Service Action: Emergency Call Button - Backlighting Is Not Working

F34 (3 Series Gran Turismo)

F36 (4 Series Gran Coupe)

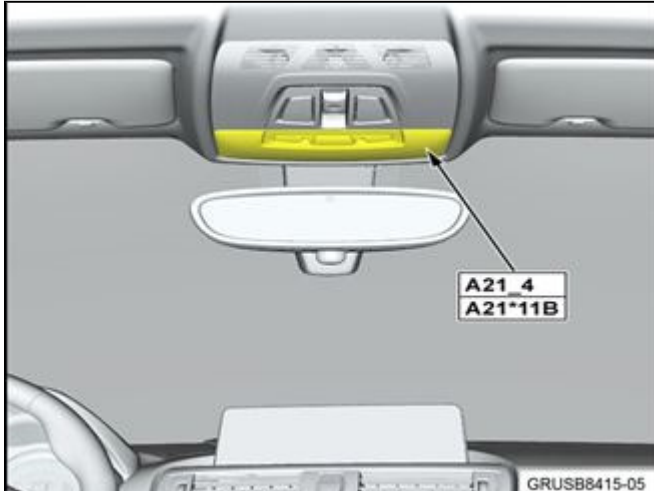
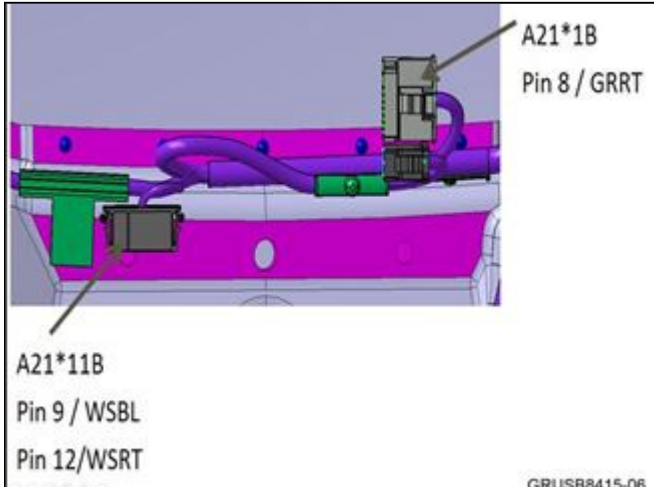
This picture shows the E-Call button illumination (back lighting) not working.
Note: Pressing the E-Call button will start an SOS call, even though the back lighting is not working.

This picture shows E-Call illumination (back lighting) working.

Missing wiring harness for the illumination of the E-Call button.

Install a retrofit harness.
